## HISTORIC PRESERVATION COMMISSION

Date: February 9, 2021

SUBJECT: Historic Area Work Permit #934708: Partial demolition and new rear addition

Applicant: Stacey Katz & Robert Fegley (Paul Treseder, Architect)  
Address: 7409 Baltimore Avenue, Takoma Park

LEFT SIDE ELEVATION.

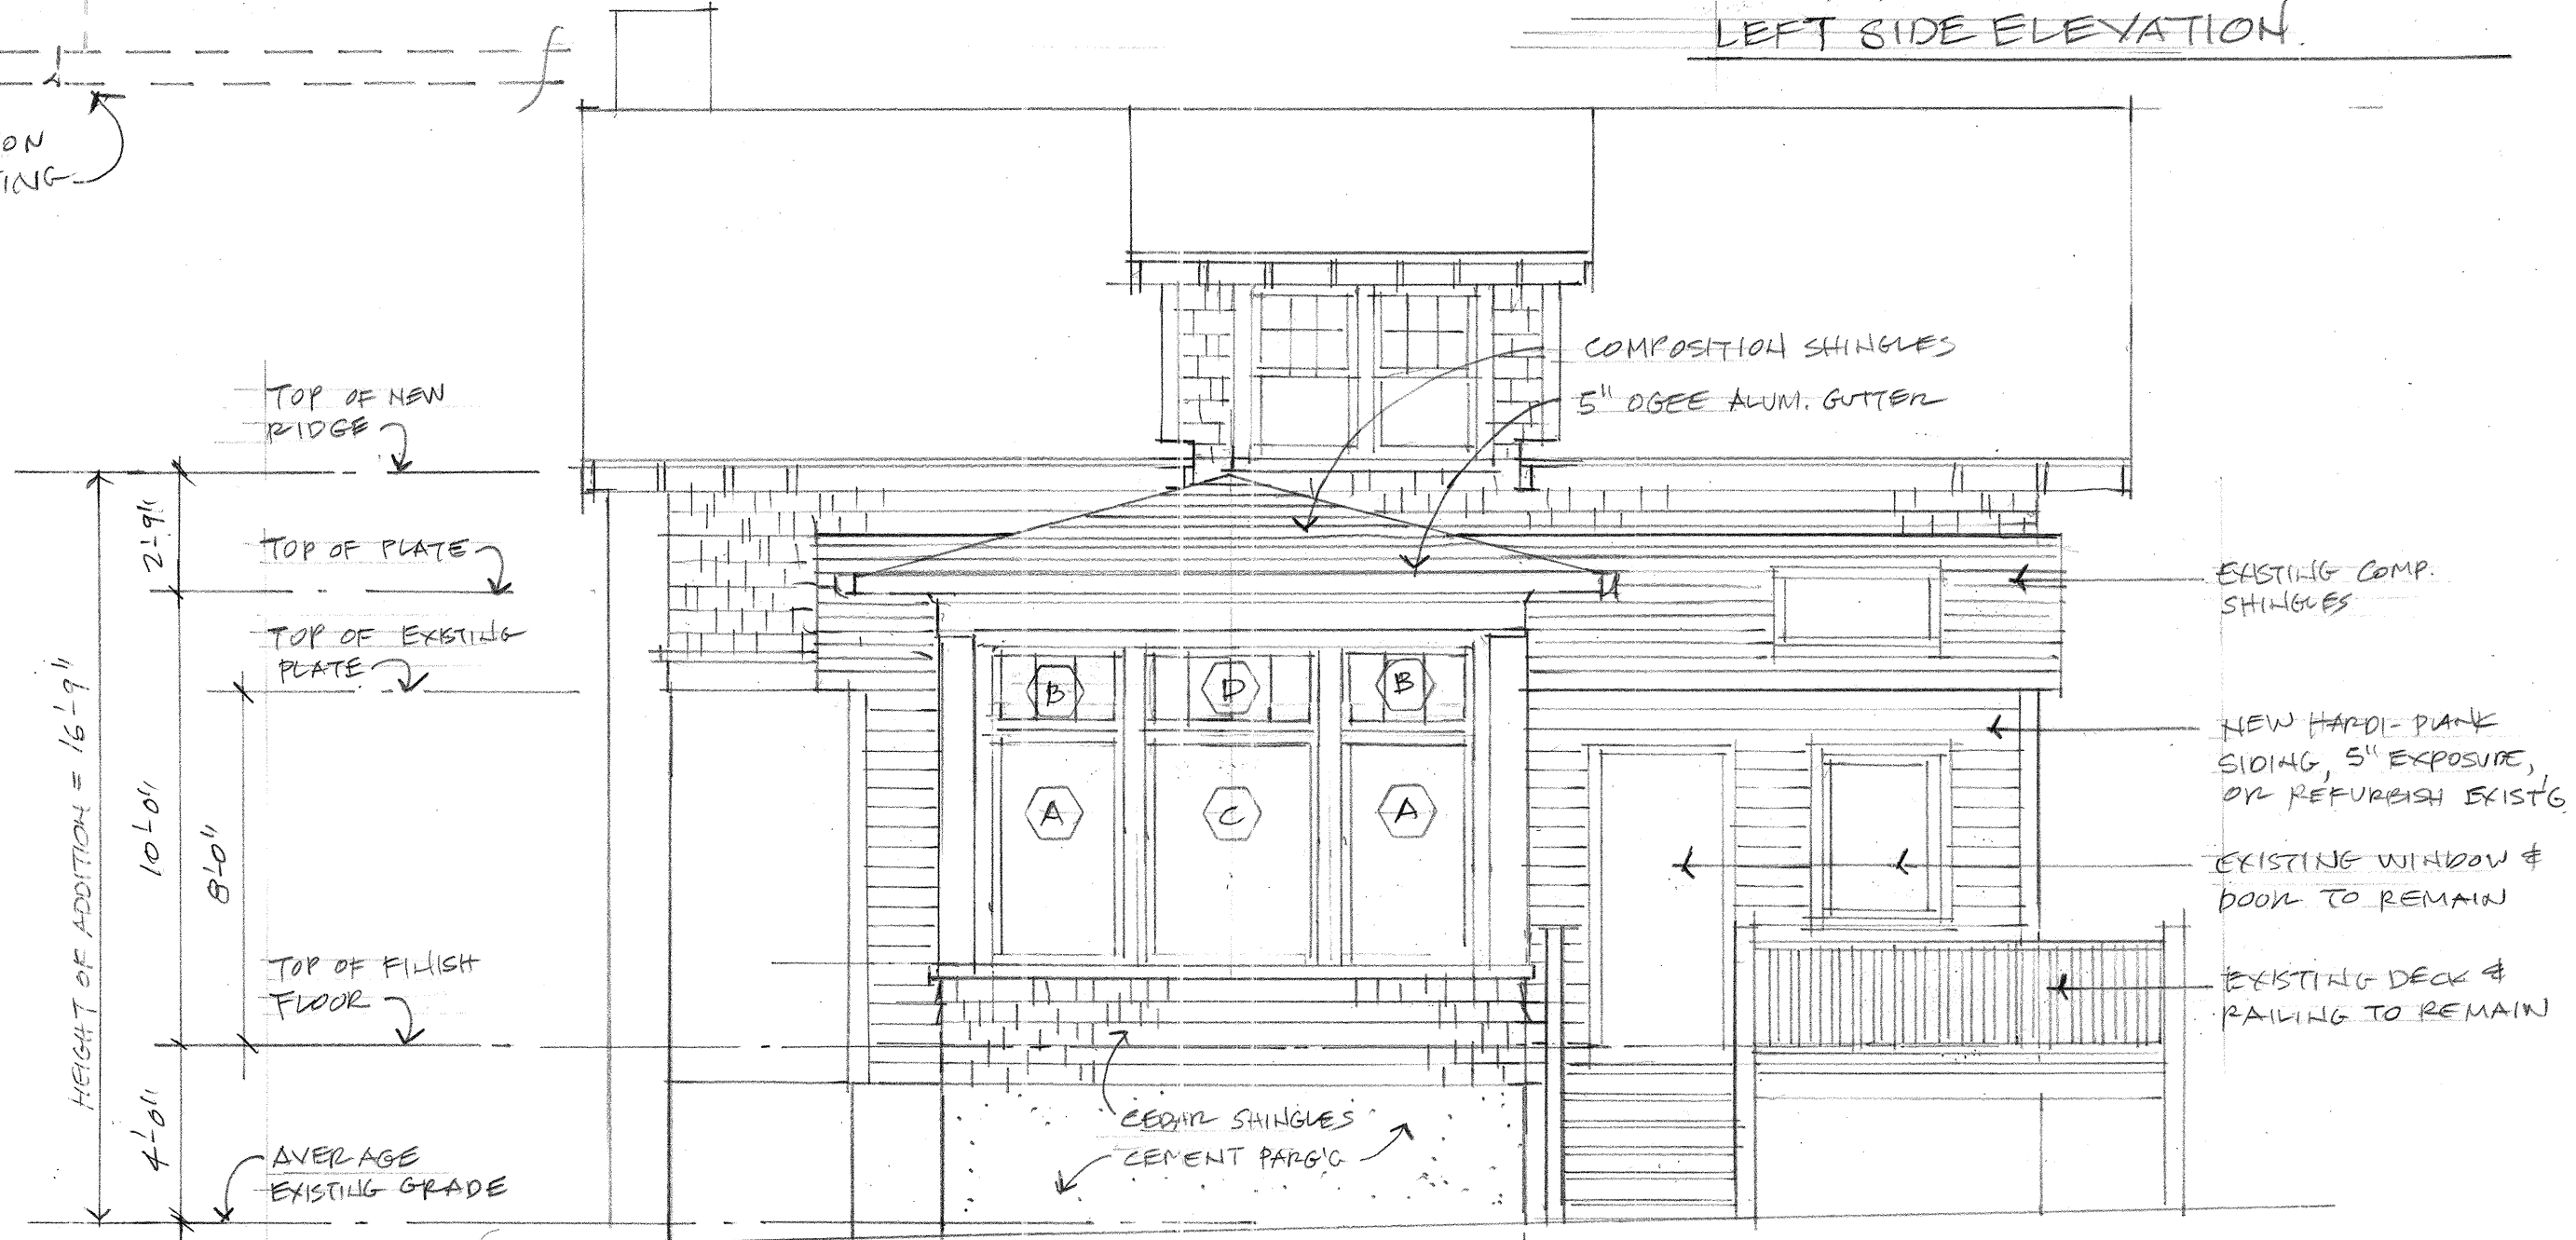
- 1. Staff will be consulted in the field on the viability of preserving any existing/historic siding that may be present, once the aluminum siding is removed from the existing addition/rear porch enclosure. If there is any existing/historic siding present, it will be preserved. If the siding is severely deteriorated, it will be replaced in-kind with wood of matching dimensions. The specifications of any required replacement siding will be reviewed and approved by staff.**

As part of this work, the owners also propose to remove the aluminum siding of the old addition and to replace it with narrow clapboards, more like what would have been used in the 1920's.

*If, upon removal of the aluminum siding, original material is found and is in condition to be restored, the owner will attempt such restoration.*
